U.S. Department  
of Transportation  
**Federal Highway  
Administration**

In Reply Refer To: HSA-10/B-139

My April 7 letter to you accepted the Ohio Department of Transportation's (ODOT) Type 5 Guardrail with Tubular Backup (ODOT GR-2.2) that is used as a barrier across low-fill culverts as a National Cooperative Highway Research Program (NCHRP) Report 350 test level 3 (TL-3) design. This acceptance was based on the similarity of the Ohio design to the Texas T101 Bridge Rail, which is currently classified as a TL-3 design, and on finite element analyses done at your facility. In your July 29 letter to Mr. Richard Powers of my staff, you requested the Federal Highway Administration's concurrence that a modified version of the ODOT GR-2.2, called the Nested Type 5 Guardrail with Tubular Backup, and a transition to the ODOT GR-2.2, called the ODOT GR-3.4 Transition, also be accepted as TL-3 designs.

ROADWAY ENGINEERING SERVICES	STDS. ENGR.	OHIO DEPARTMENT OF TRANSPORTATION	X-XX-XX
	D. Focke	ROADWAY DESIGN ENGINEER	DATE
STANDARD ROADWAY CONSTRUCTION DRAWING	NUMBER		
<b>NESTED TYPE 5 GUARDRAIL WITH TUBULAR BACKUP</b>	GR-2.2		
1	2

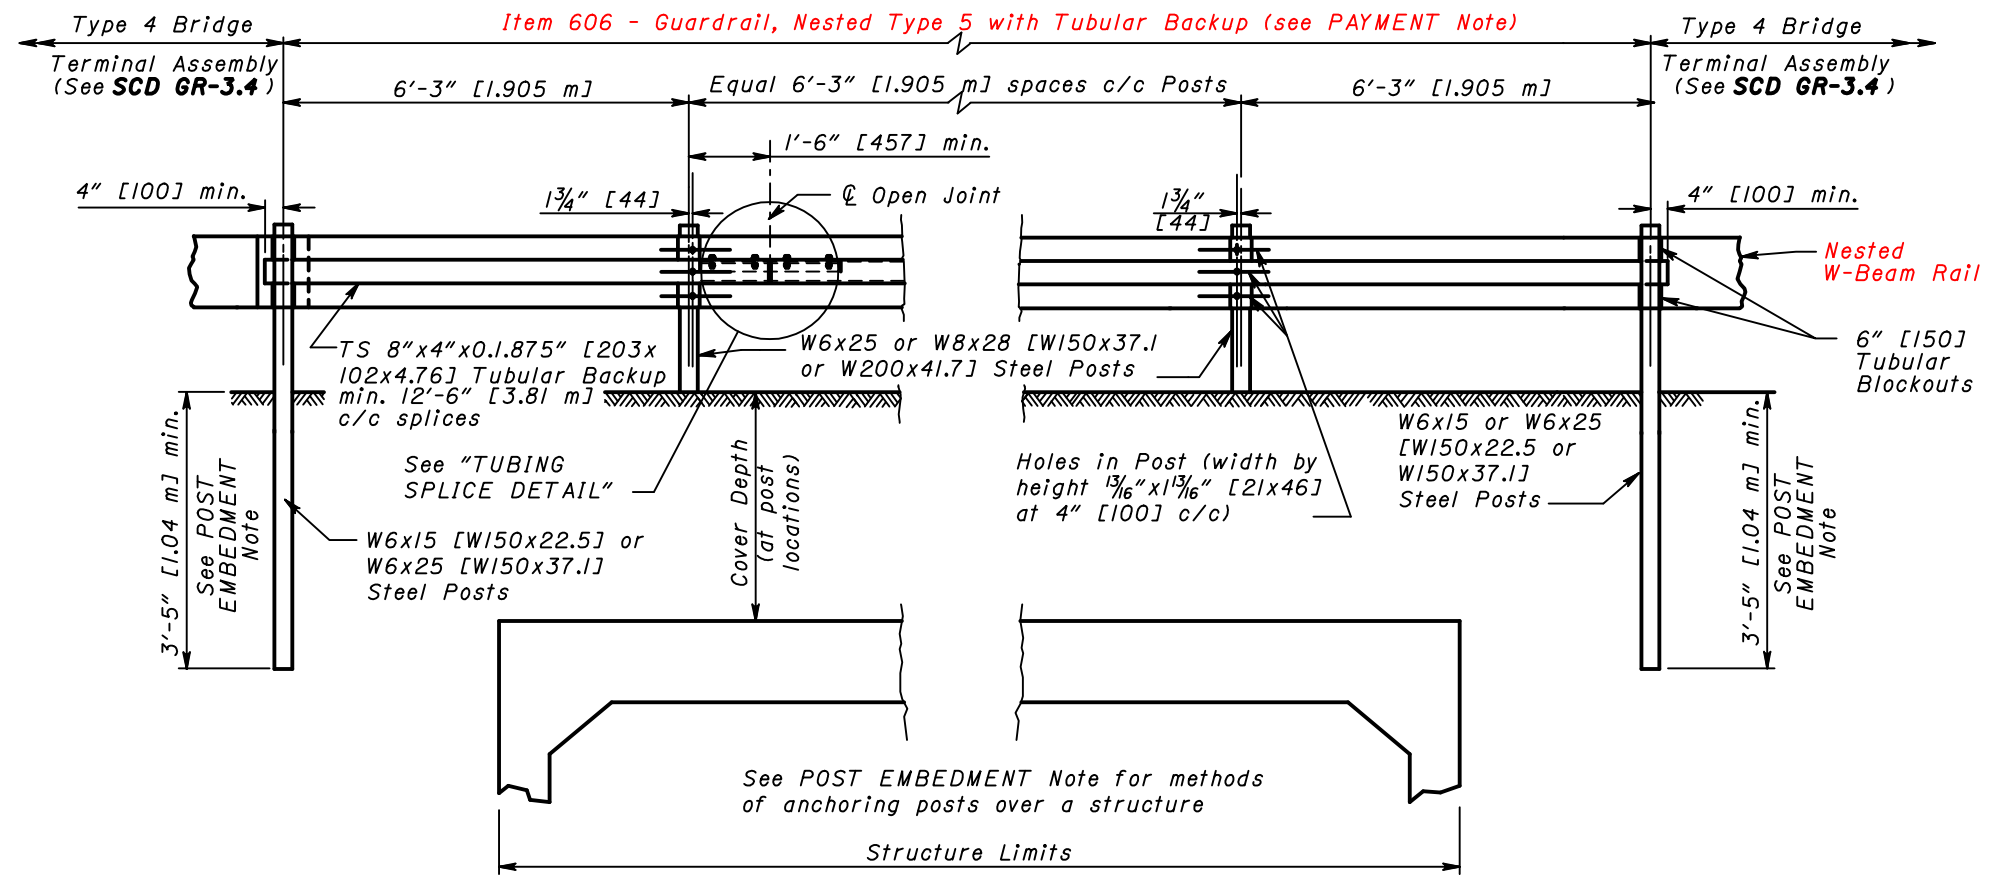
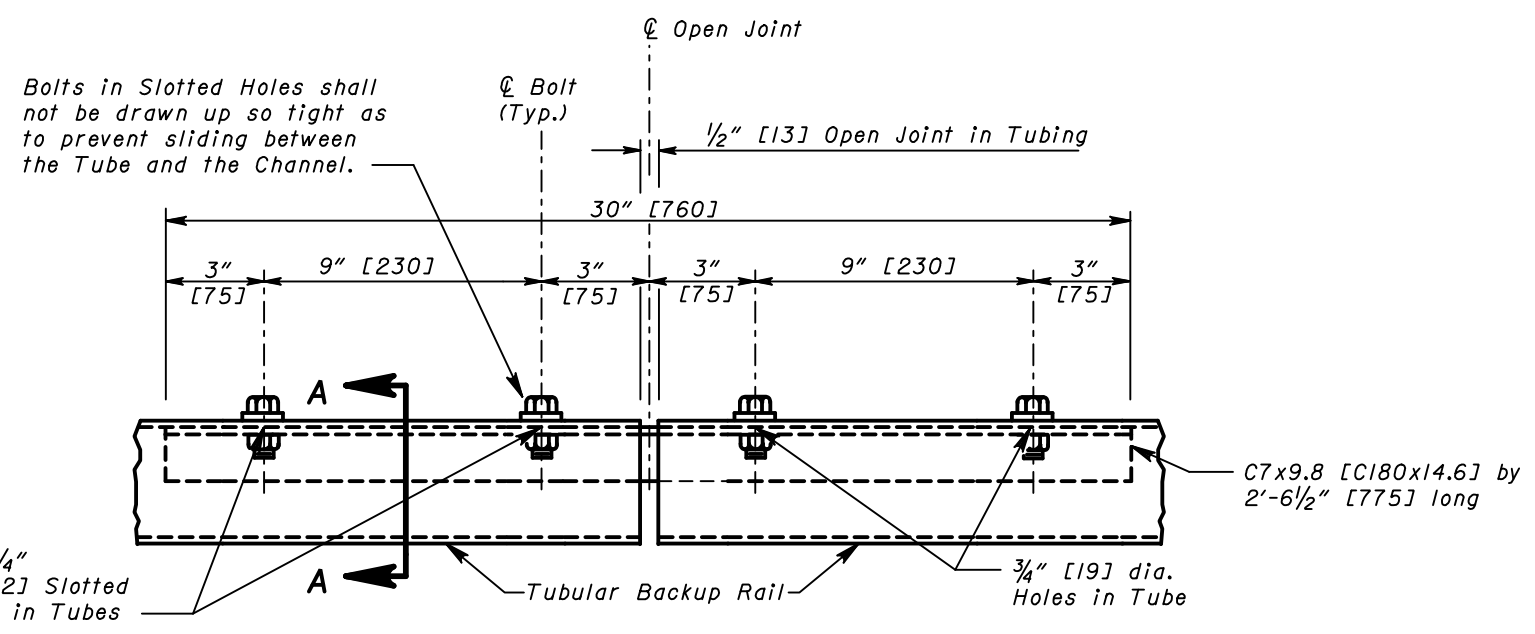
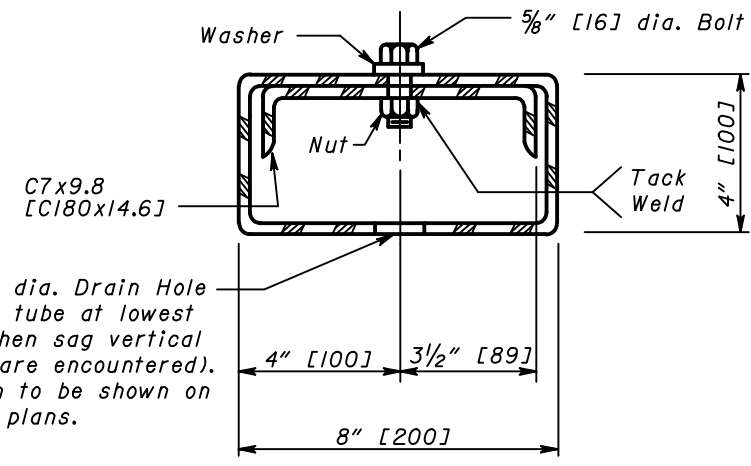
The modified ODOT GR-2.2 design differs from the original version by using nested 12-gauge sections of W-beam in lieu of the original single rail element. This modification stiffens the ODOT GR-2.2 to make its deflection more comparable to the ODOT GR-3.4 transition at the connection points of the installation. The ODOT GR-3.4 transition uses one 13'-6" nested

The results of the finite element analyses indicated that nesting the rail throughout the ODOT GR-2.2 length to match the nested W-beam in the transition design eliminated the potential for snagging at the connection point and, consequently, the ridedown accelerations were significantly reduced. Furthermore, the analysis results of the original design indicated that some wheel snag on guardrail posts might be expected at impact angles greater than 25 degrees, i.e. the lower part of the W-beam in the original design is likely to fold under the tubular backup in higher severity impacts, due to the low stiffness of the single W-beam element, and allow the wheel of the vehicle to pass underneath the rail. The *nested* W-beam rails of the modified ODOT GR-2.2 sufficiently stiffen the guardrail to prevent the wheel of the pickup truck from pushing underneath the rail, thus reducing the potential for wheel snag on guardrail posts. Based on the results of the analysis, the integrated system of the Nested Type 5 Guardrail with Tubular Backup and the ODOT GR-3.4 transition was recommended as a final design.

Based on your analyses, I agree that the modified ODOT GR-2.2 and ODOT GR-3.4 designs, as described above and used together, may be considered the NCHRP Report 350 TL-3 designs and used on the National Highway System at the State's discretion.
